How to Handle negative “delta_COM” in the COM Matlab Code

COM Commit Request Number 4p8_2

Hossein Shakiba

April 08, 2025

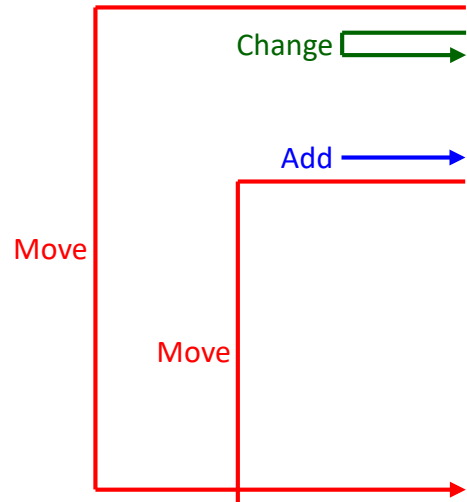
- During investigations related to COM Commit Request Numbers 4p8_1, a case was observed that would result in negative calculated delta_com due to excessive noise caused by double counting of the RxFFE noise amplification
- The negative value is overridden to 0 when delta_COM is reported
- However, the code proceeds with the negative value and consequently reduces COM, which could even become negative:

- Hopefully commit Request Number 4p8_1 fixes this issue (as it did for this case):
- Nevertheless, the question is: Should the overridden delta_COM be used thereafter?

- 😊 “the Good” : Using the overridden `delta_COM` of 0 to proceed with overall COM calculation, ensures that in cases where MLSE is deemed to be destructive it won't be used
- 😞 “the Bad” : However, such cases are not expected to happen and if they do, it is likely because of the synthesized approach taken to mimic the implementation penalty, and using the overridden value masks the visibility of these unexpected, but potential, cases
- The override was a precaution to ignore MLSE if signal quality was poor for clock recovery
- With the lack of a more realistic approach to calculating the implementation penalty (beyond the scope of COM ad hoc), the following is suggested:
 - ❖ Apply “the Good” and
 - ❖ Report the calculated negative `delta_COM` to keep the visibility of “the Bad”
 - ❖ Apply the override to `delta_COM_notrunc` as well

Apply overridden
delta_COM thereafter

Report calculated
delta_COM for visibility

Override negative
delta_COM_notrunc
